**TOWN OF MOUNTAIN VILLAGE
REGULAR DESIGN REVIEW BOARD MEETING
THURSDAY MARCH 28, 2019 10:00 AM
2nd FLOOR CONFERENCE ROOM, MOUNTAIN VILLAGE TOWN HALL
455 MOUNTAIN VILLAGE BLVD, MOUNTAIN VILLAGE, COLORADO
AGENDA**

DATE: March 18, 2019
TO: Design Review Board
FROM: Sam Starr, Planner
FOR: DRB Public Hearing on March 28, 2019
RE: Consideration of a Design review application for CeDUR synthetic roofing, which requires a specific approval from the DRB, on Lot 601 Unit 34, 307 Fairway Drive.

TO: Design Review Board
FROM: Sam Starr, Planner
FOR: Meeting of March 28,2019
DATE: March 21, 2019
RE: Consideration of a Design Review: Initial Architectural Site Review application for a new single-family dwelling on Lot 165-13, 230 Cortina Drive.

ZEHREN AND ASSOCIATES, INC.
ARCHITECTURE - PLANNING - INTERIORS
LANDSCAPE ARCHITECTURE
101 El Paseo
Santa Barbara, California 93101
(805) 963-6890 FAX (805) 963-8102

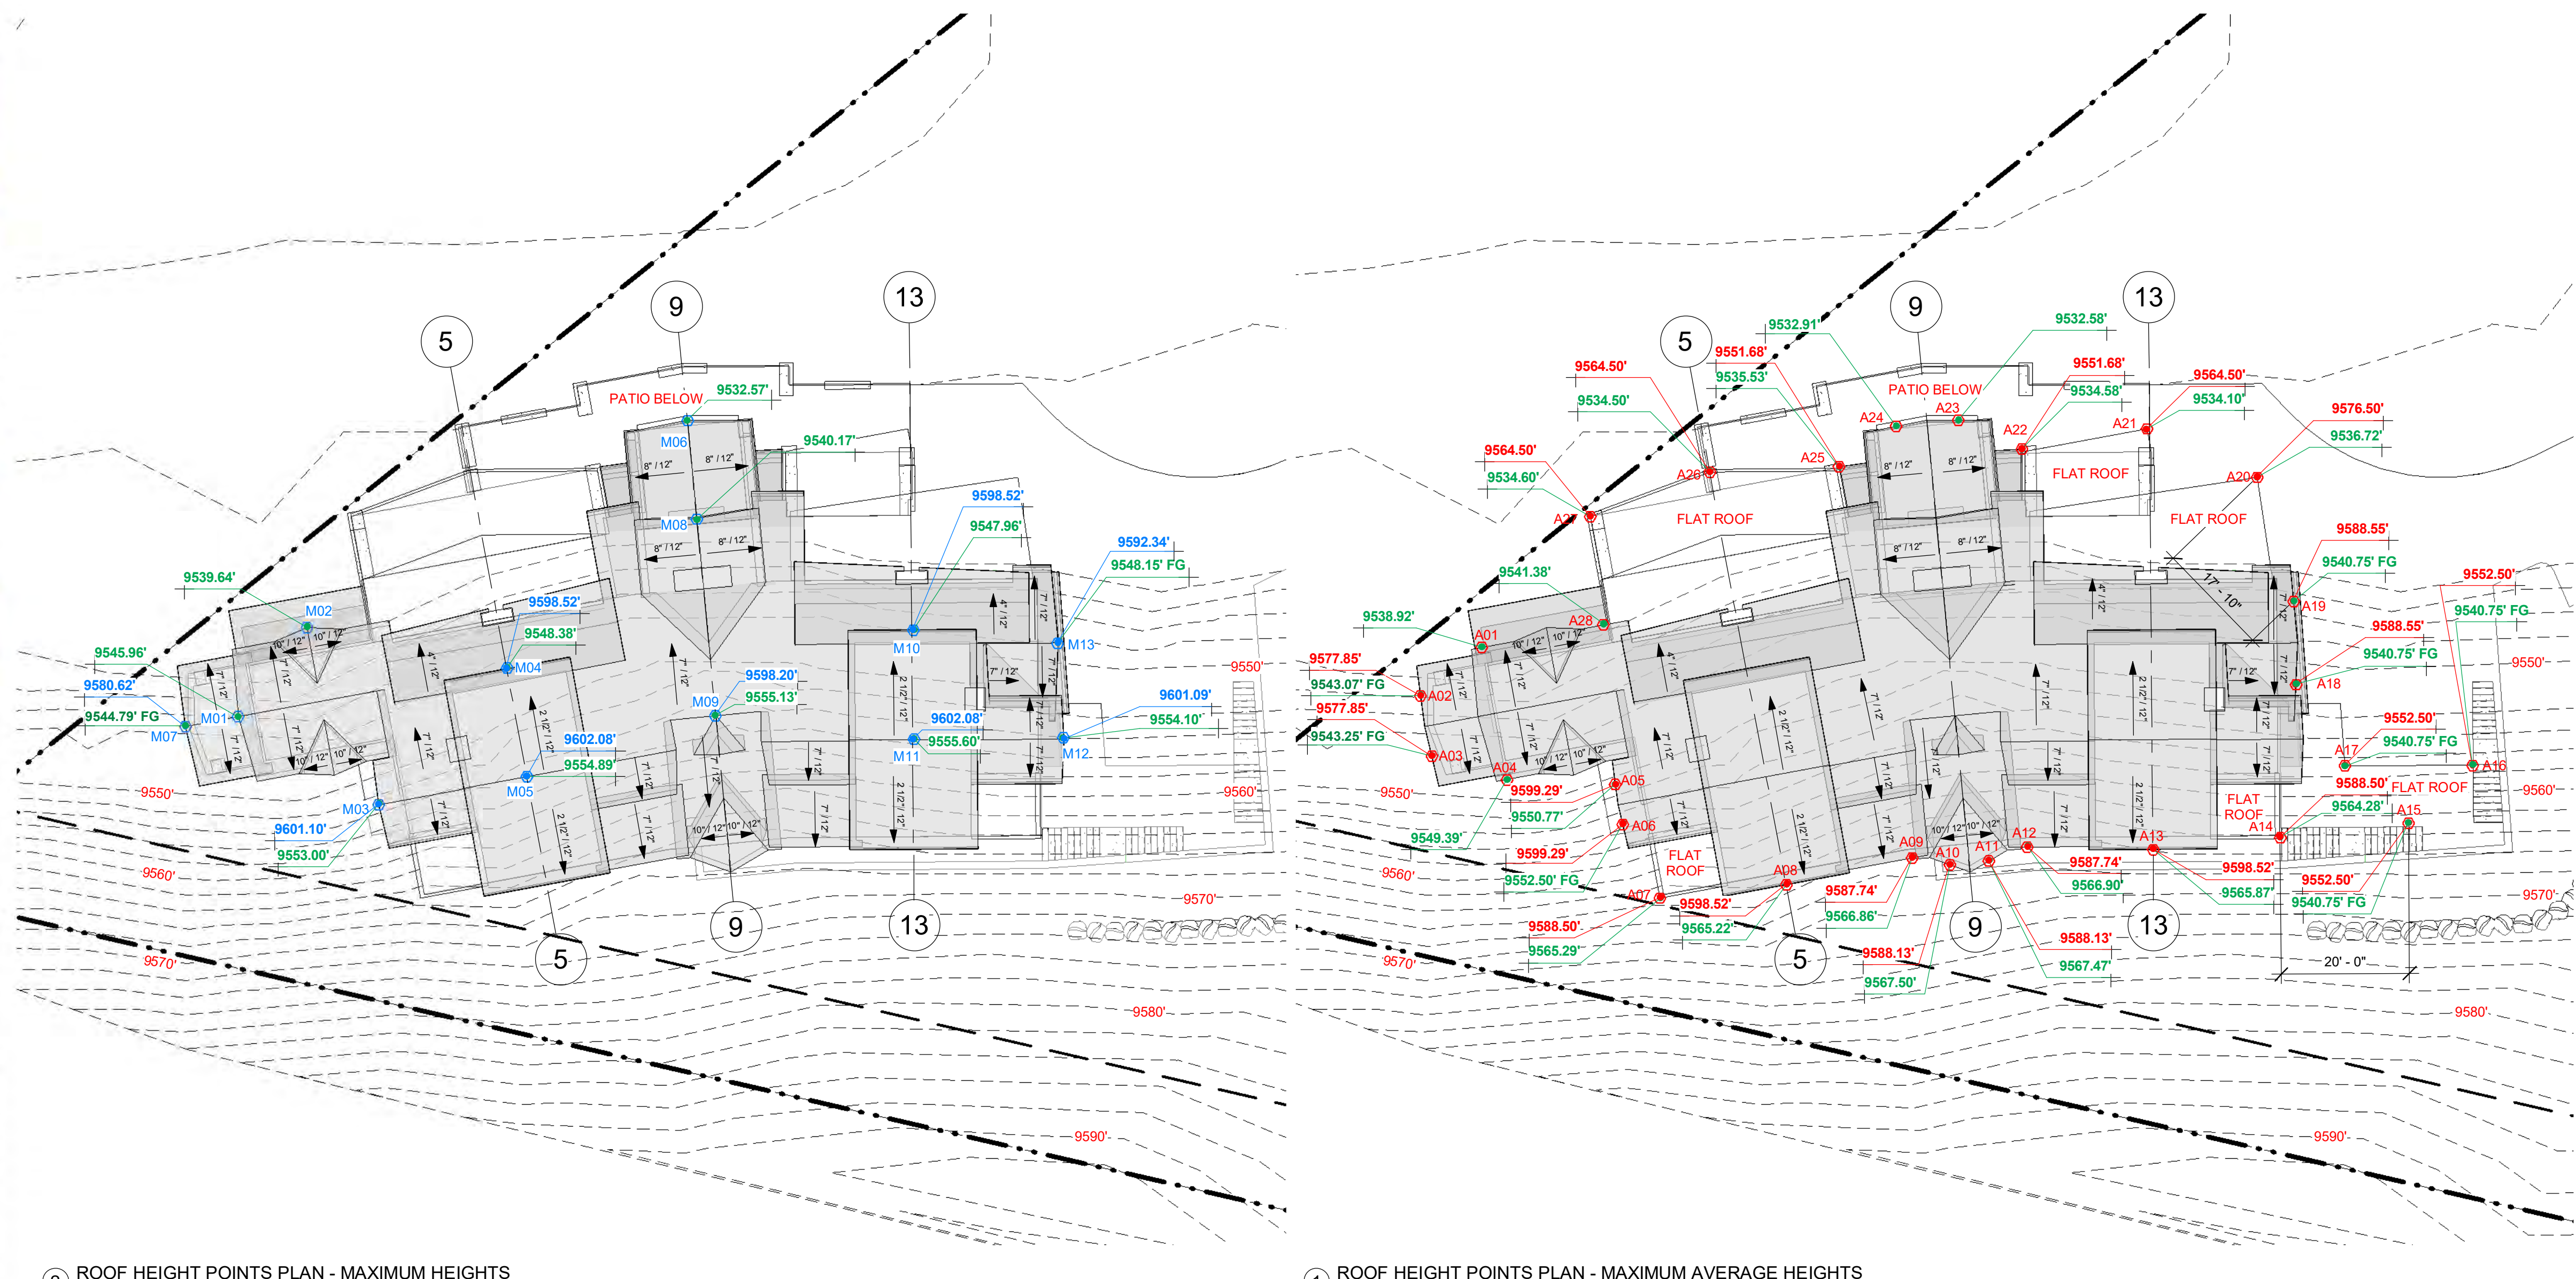
Staff: The applicant has provided a height analysis that demonstrates both Maximum Roof Height Calculations as well as Average Maximum Roof Height Calculations. According to page H1.00 of the plan set, the average height for the proposed designed is compliant at 39.79 feet and the highest point above the most restrictive grade is M08 which has a max height of 52.91 feet. The applicant has provided an average height analysis demonstrating all measurement points above the most restrictive grade, along with elevations demonstrating the height analysis showing a parallel slope analysis demonstrating compliance and all areas other than those in which the chimney penetrates the 53-foot parallel slope of nature.

1 SITE PLAN
 L1.01 SCALE: 1" = 10'-0"

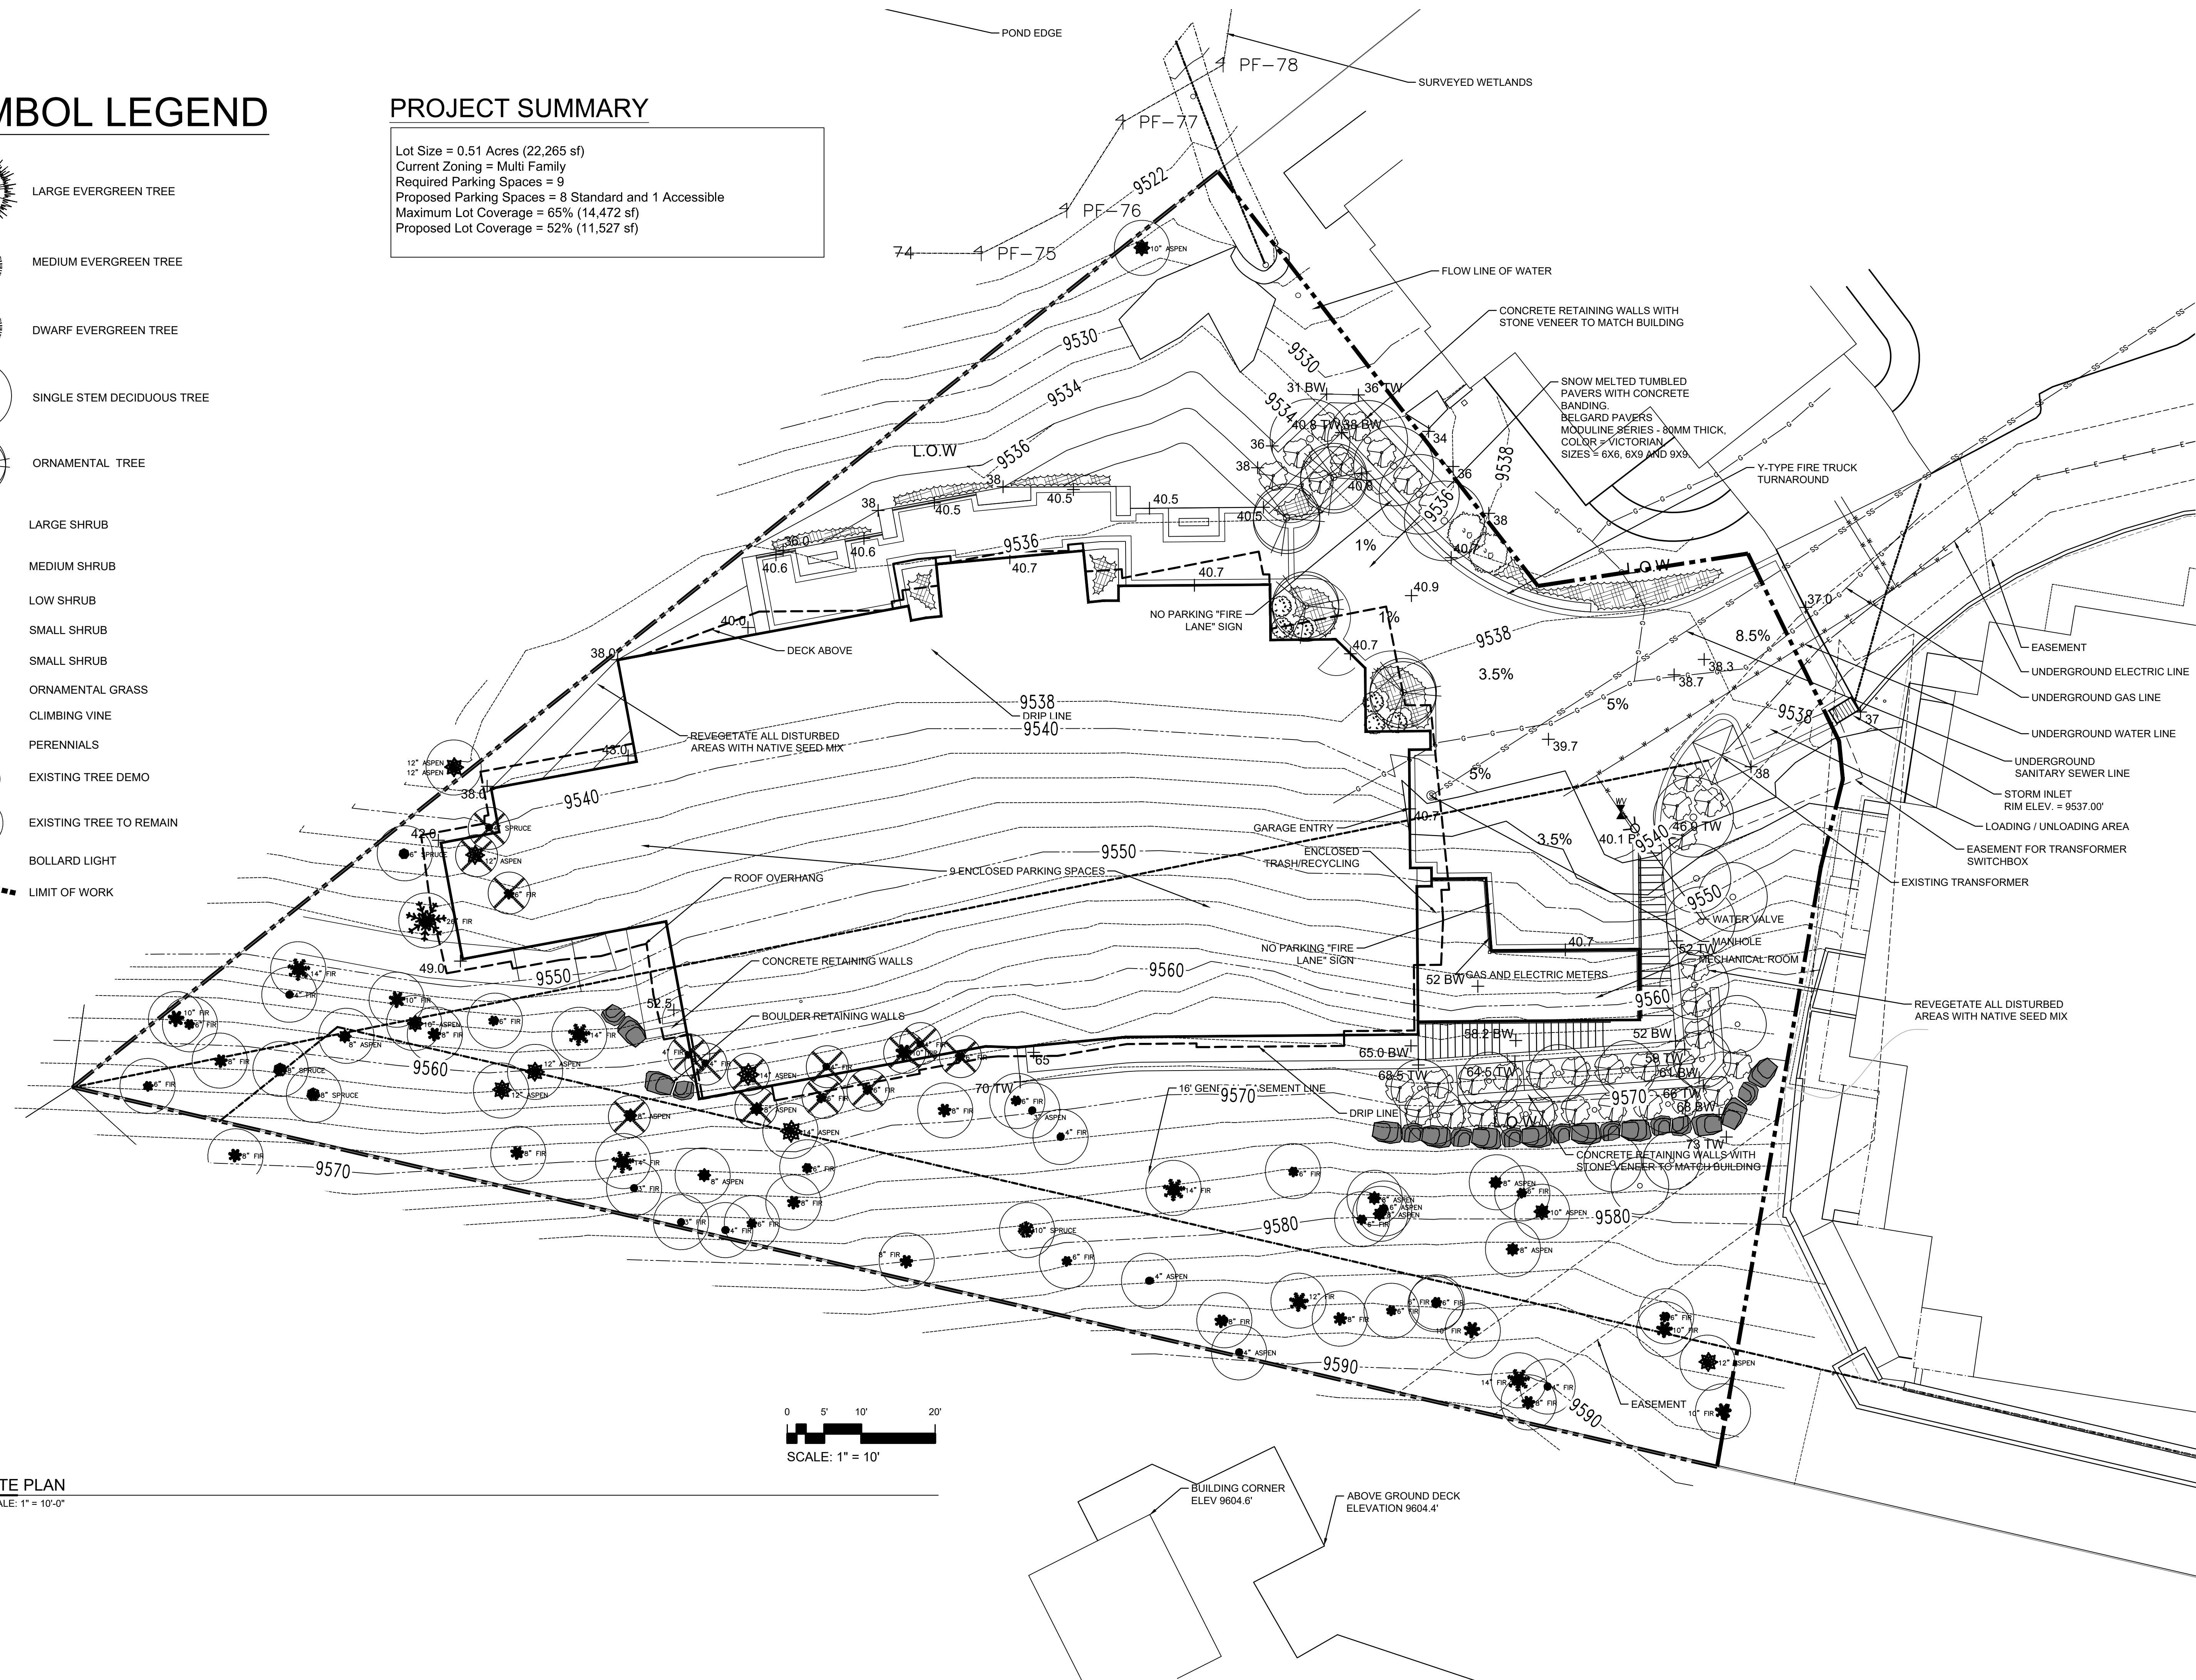
Staff: The applicant has not provided a full landscaping plan but rather an initial site plan the demonstrates specific landscaping features such as areas of tree removal and areas of proposed landscaping. Prior to Final Architectural Review, the applicant will be required to demonstrate irrigation methods, methods to preserve existing trees to remain, along with specific planting schedules for all proposed shrubs and plantings on the site.

Staff: The applicant has not provided a lighting plan for the project. It's unclear to staff as to the types and amounts of proposed fixtures on the site. Due to the size of the project along with the adjacent sensitive riparian areas, staff is recommending that the applicant provide a full lighting plan including an iso-metric foot-candle study along with full cut sheets for all the proposed lighting fixtures for the site. It would be beneficial when developing this plan to take into account the adjacent residences along with the riparian area of Elk Pond when designing lighting fixture locations, lighting temperature, and lumens. Ideally, the applicant would limit the use of exterior fixtures within the area that may spill over into the riparian areas to the north west of the project.

- 3) Prior to Final Architectural Review, the applicant shall provide a total calculation of exterior areas to have snow melt systems, and revise page L1.01 to indicate those areas in the plan set.

- 7) Prior to Final Architectural Review, the applicant will be required to update the landscaping plan in order to demonstrate irrigation system design, methods to preserve existing trees which are to remain, along with specific planting schedules for all proposed shrubs and plantings on the site.

- 9) Prior to Final Architectural Review, staff is recommending that the applicant provide a full lighting plan including an iso-metric foot-candle study along with full cut sheets for all the proposed lighting fixtures for the site. The iso-metric foot candle study should specifically address light spill into the wetlands / riparian areas of Elk Pond.
